PoE Plus IEEE 802.3at Classification Ad Hoc

Resolving Draft 1.0 Comments in L1 Bucket

Clay Stanford Linear Technology January 21, 2008 Portland

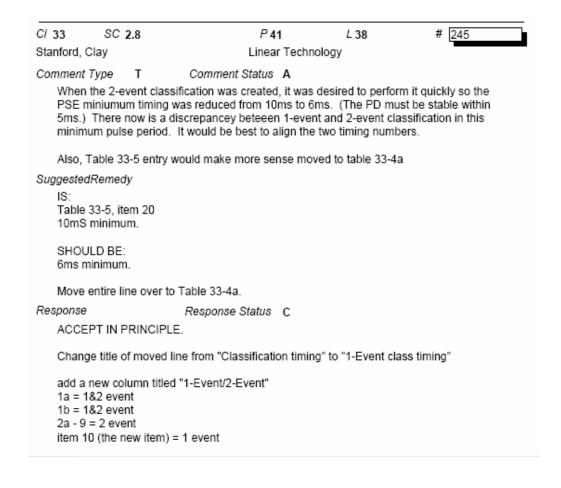
Comment 129 suggests 1-Event and 2-Event PSEs should have same time measurement delay requirement. Ad hoc agrees.

Comment 245 was accepted and suggested aligning Type 1 and Type 2 class timing. However, editor instructions do not this state explicitly. Ad hoc suggests Table 33-4a, entry 10 minimum time changed from 10ms to 6ms.

Modify comment 243: Accept in principle, but change wording p37L43: IS: Measurement to be taken after 6ms to ignore initial transients.

SHOULD BE: Measurement to be taken

after Tpdc to ignore initial transients.
ADD p37L54: Measurement to be taken after Tcle1 to ignore initial transients.
ADD p38L28: Measurement to be taken after Tcle2 to ignore initial transients.
